April 11, 2019

To: Ridgeland WRF Expansion Plan Holders

Re: Addendum #1
Ridgeland WRF Expansion

<i>Town</i>	<i>PROJECT</i>	<i>Jimmy</i>	<i>SHEET TIT</i>	<i>Sludge</i>
SHEET NO.		OF		
M801		---		
FILE NO.				
1636.6

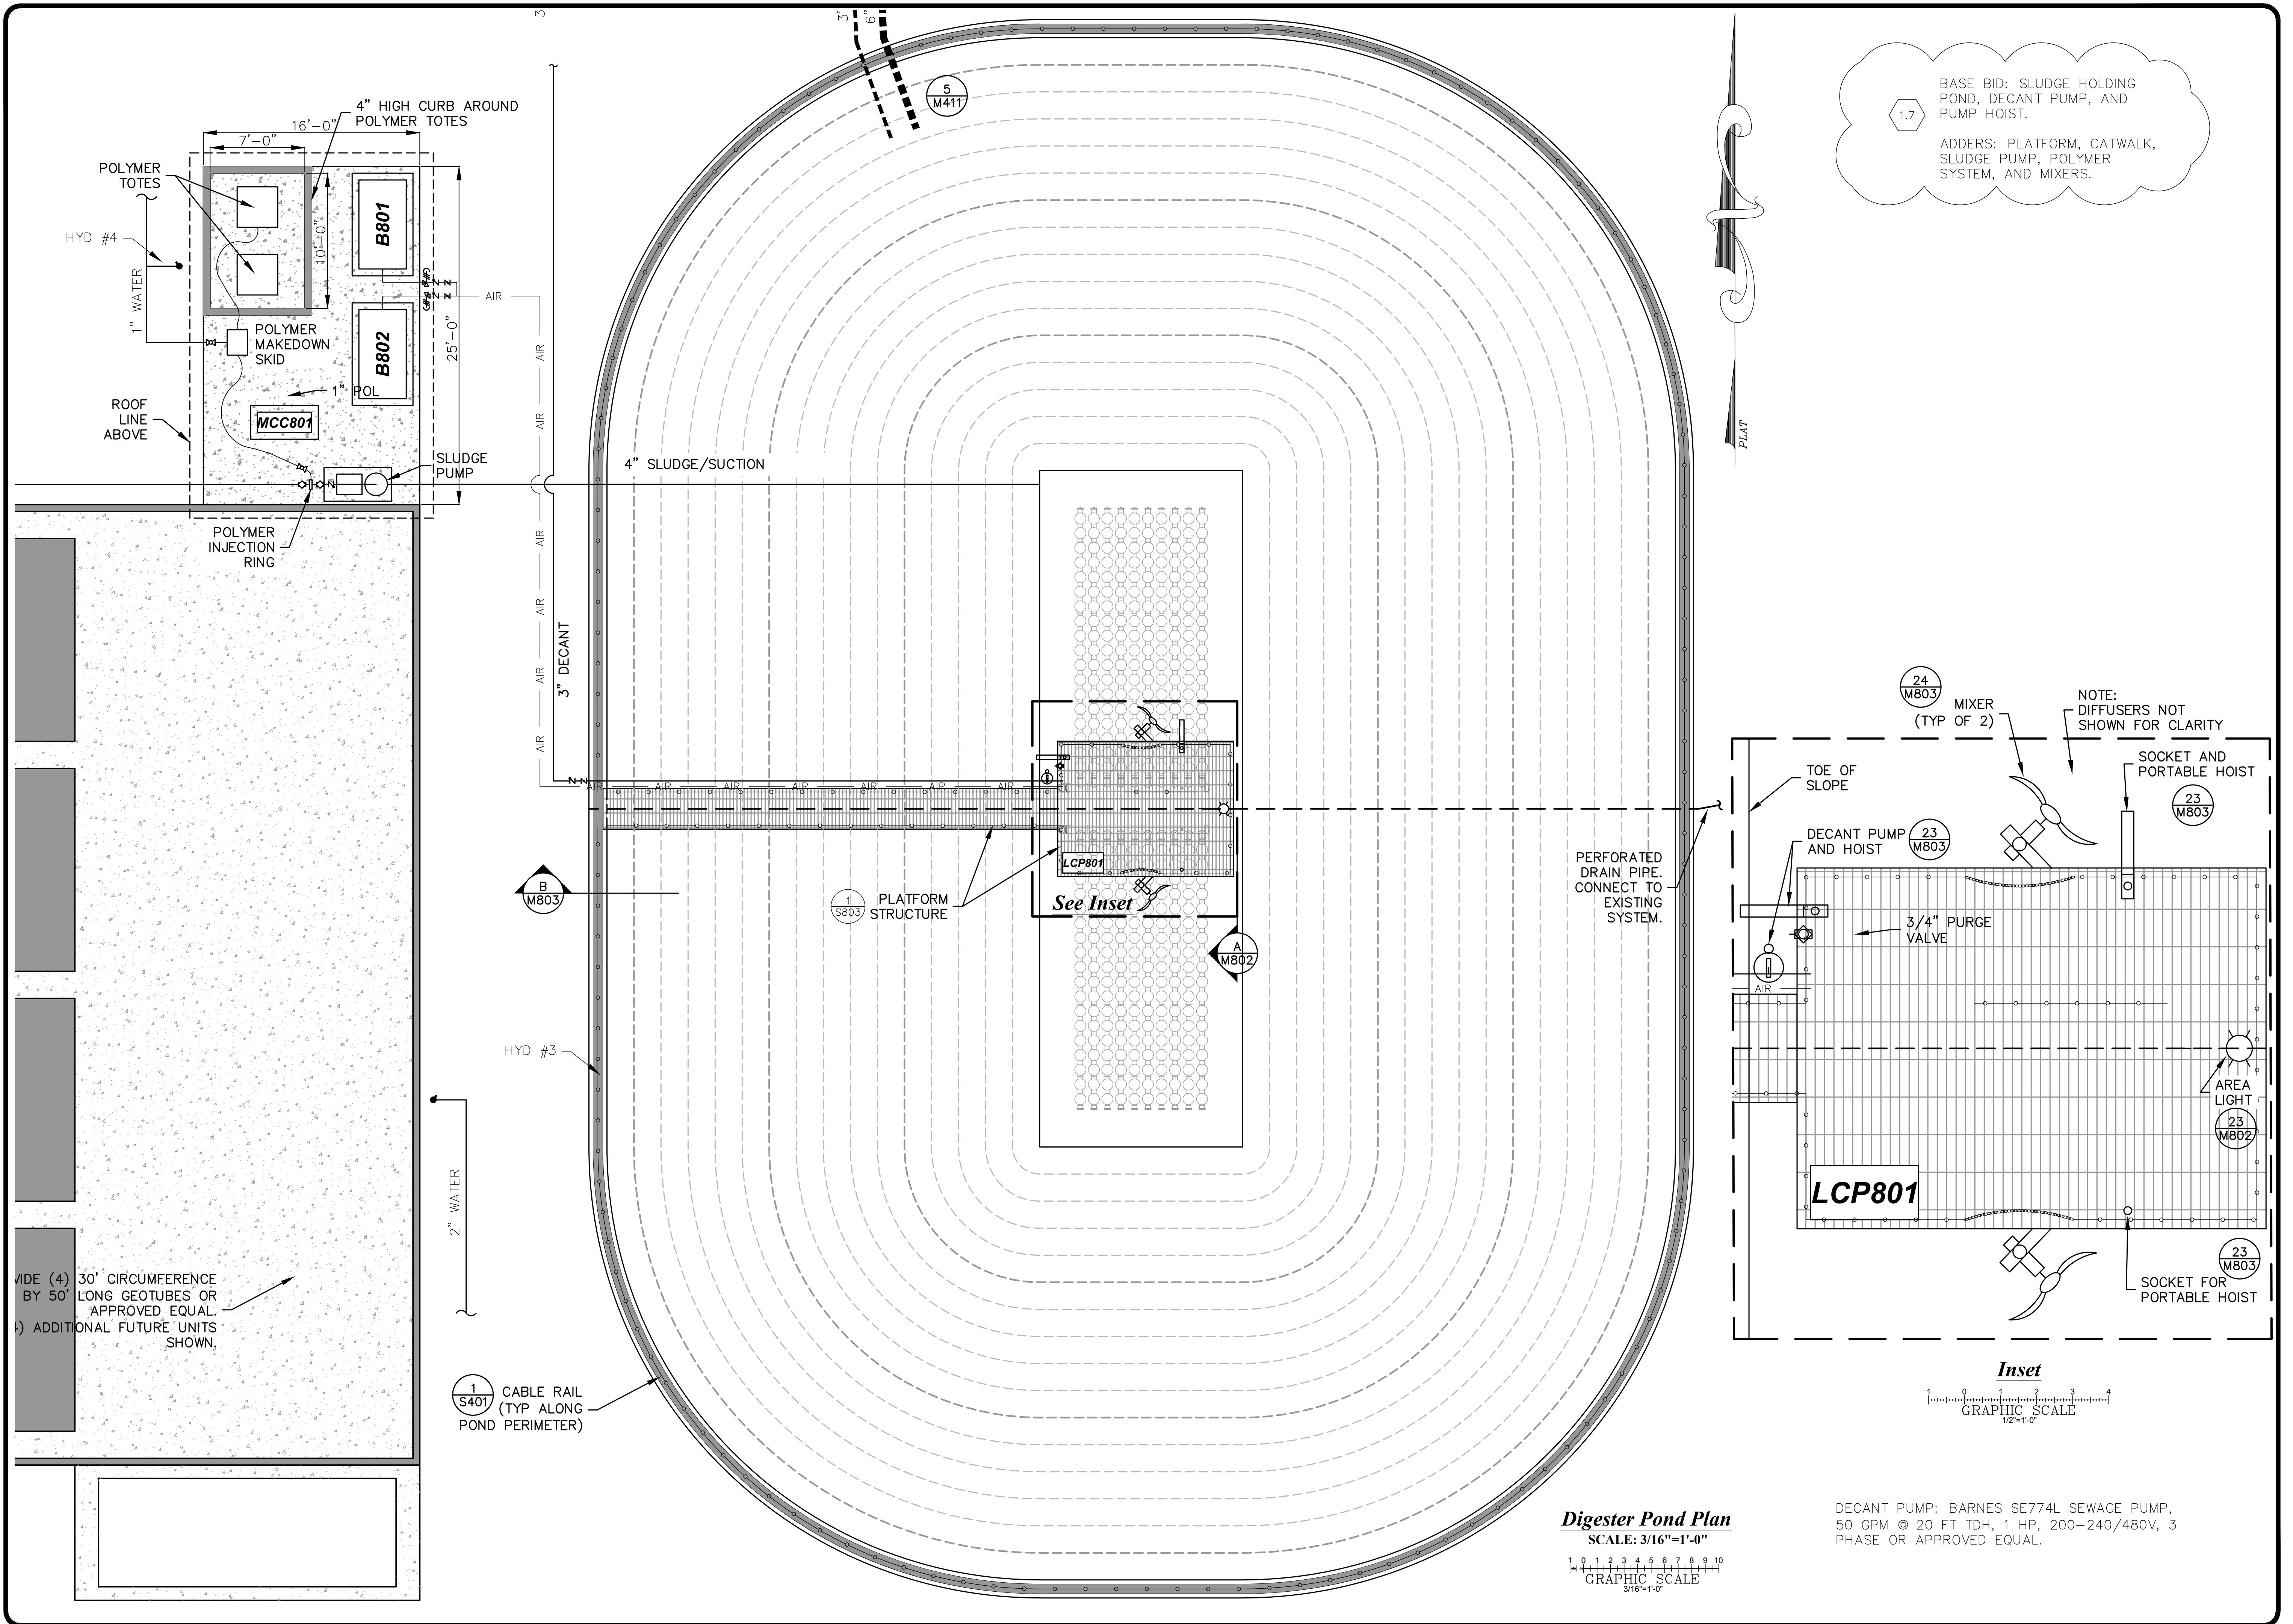
1.7	Digester - G004 - Hyd profiles, ESC002, M800s & S800s	<ol style="list-style-type: none"> Base bid: Sludge holding pond, submersible decant pump, pump hoist Adder: Blowers, diffusers, mixers, catwalk, platform, area light

SHEET NO.: **M802** OF: **--**
FILE NO.: **1636.6**
Sludge Digester Pond

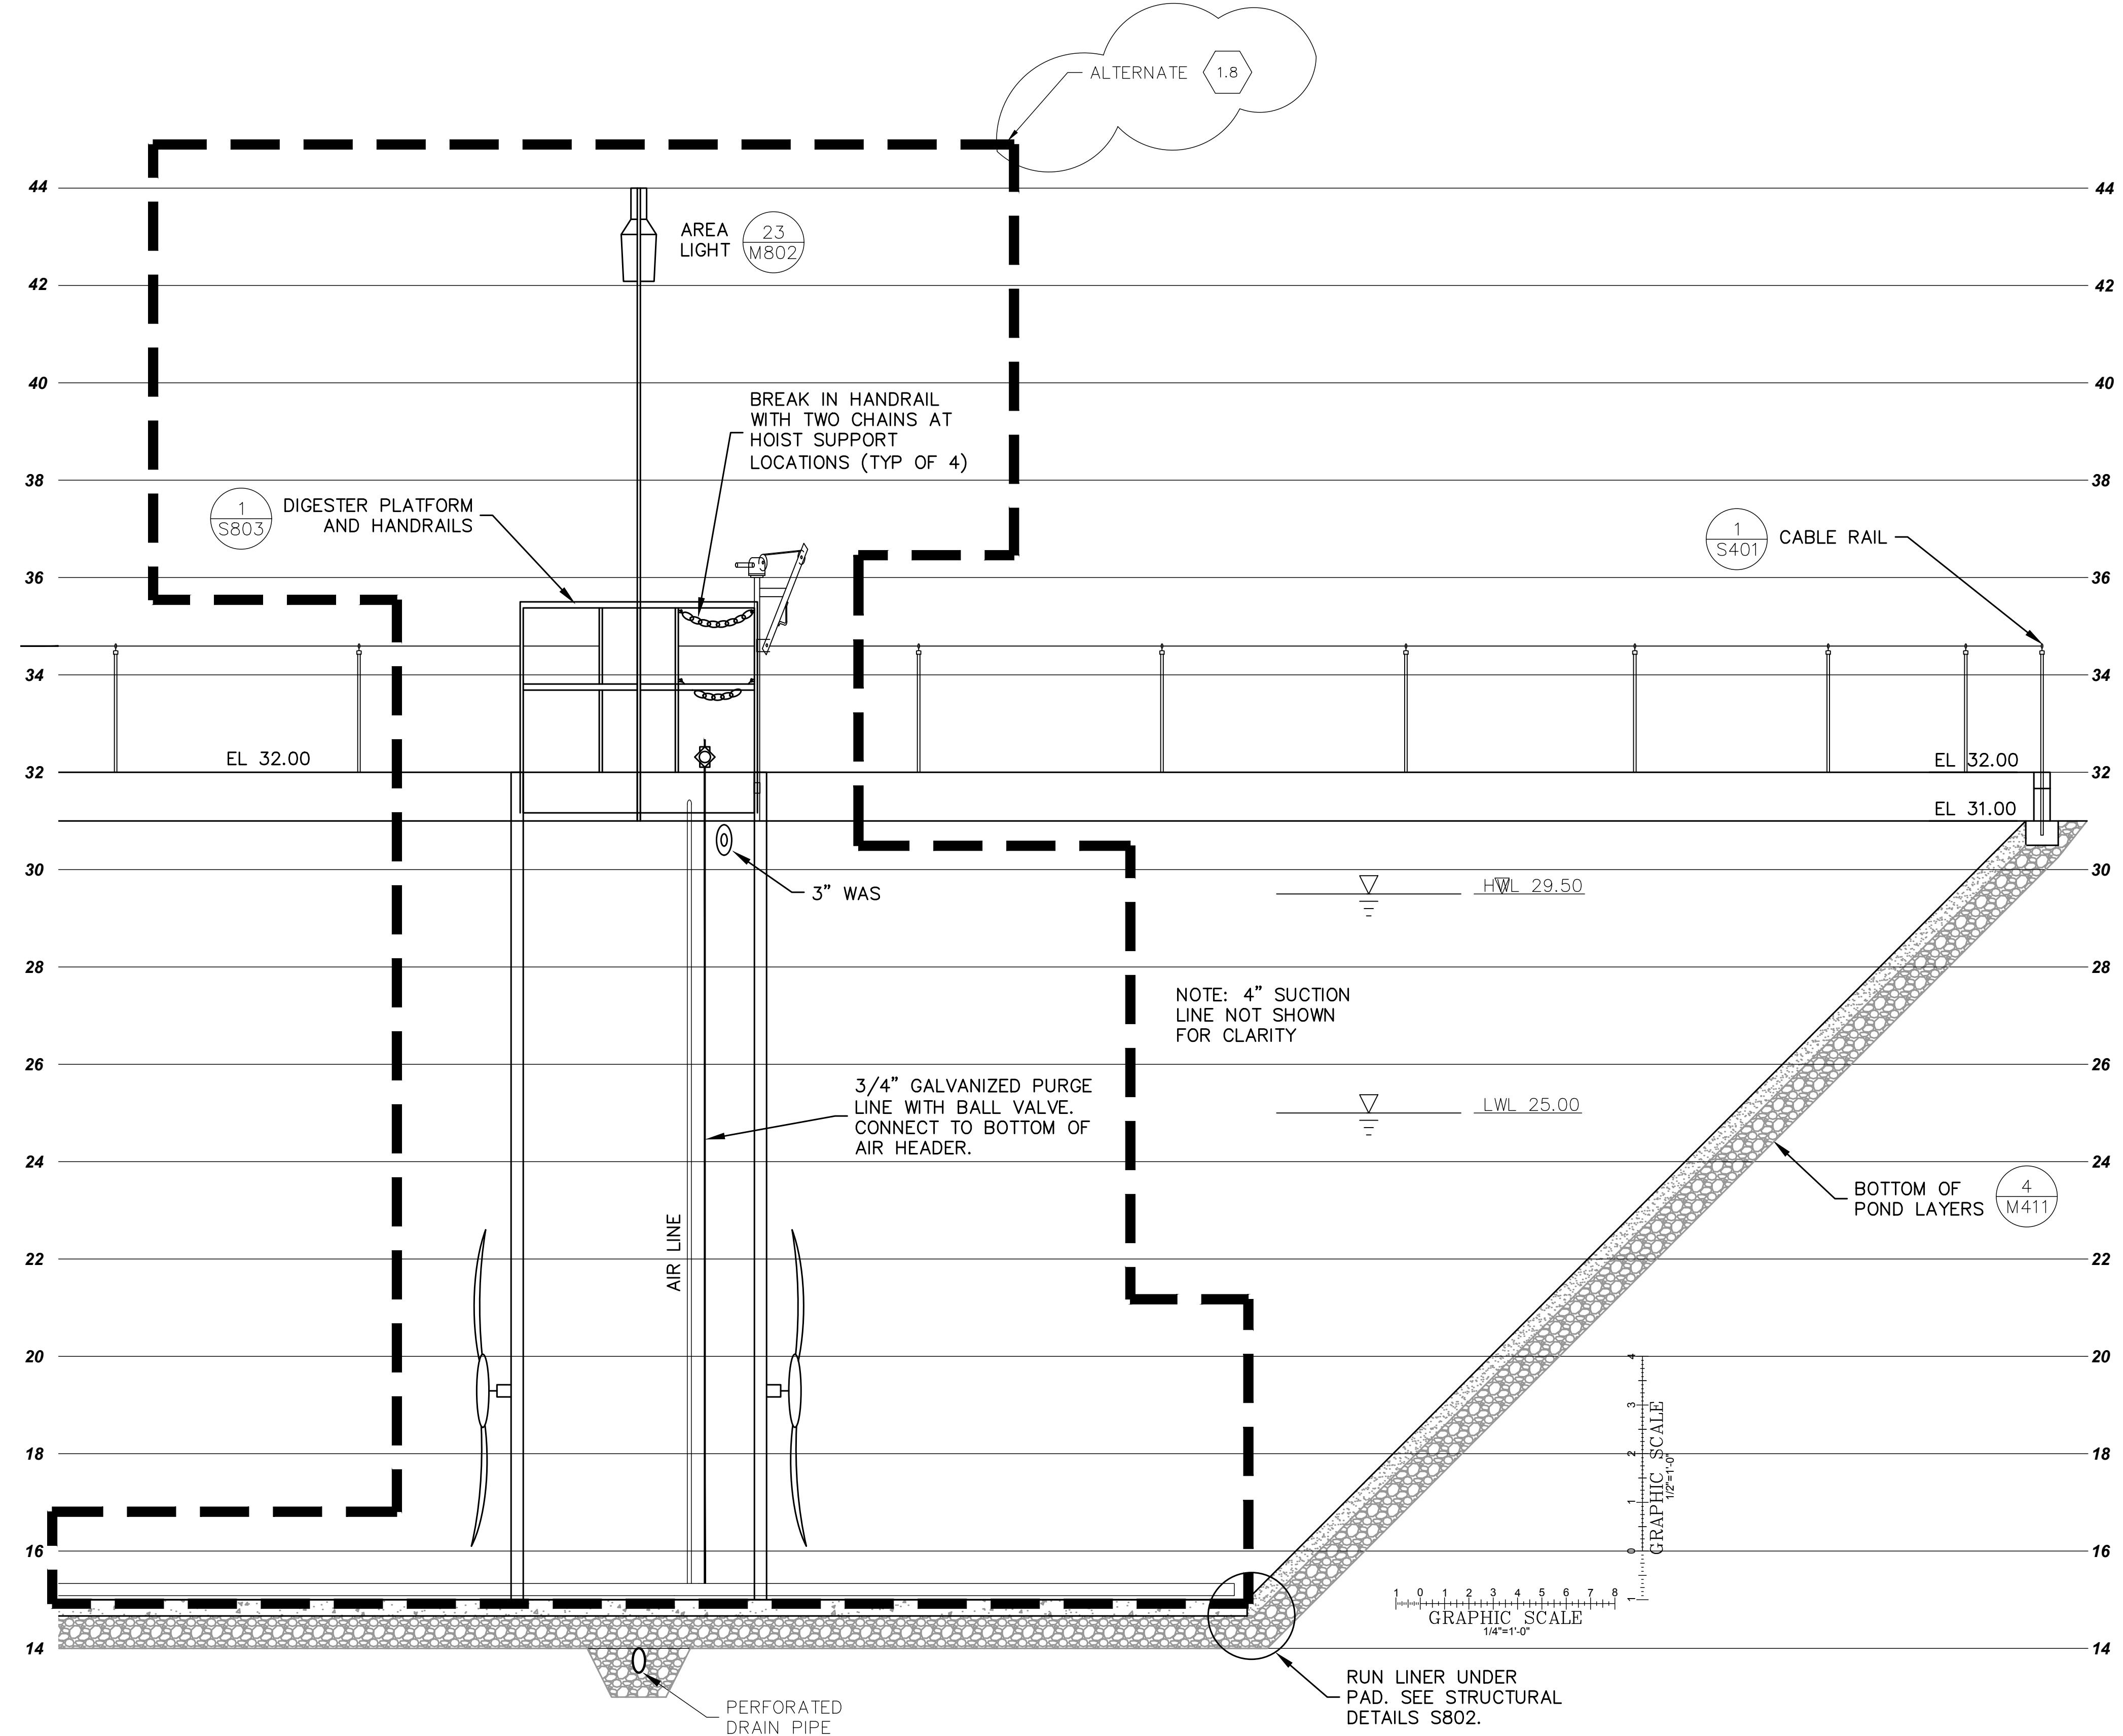
1.7 BASE BID: SLUDGE HOLDING POND, DECENT PUMP, AND PUMP HOIST.
 ADDERS: MIXERS, DIFFUSERS, CATWALK, AREA LIGHT
 1.8 SLUDGE SUCTION PIPE.
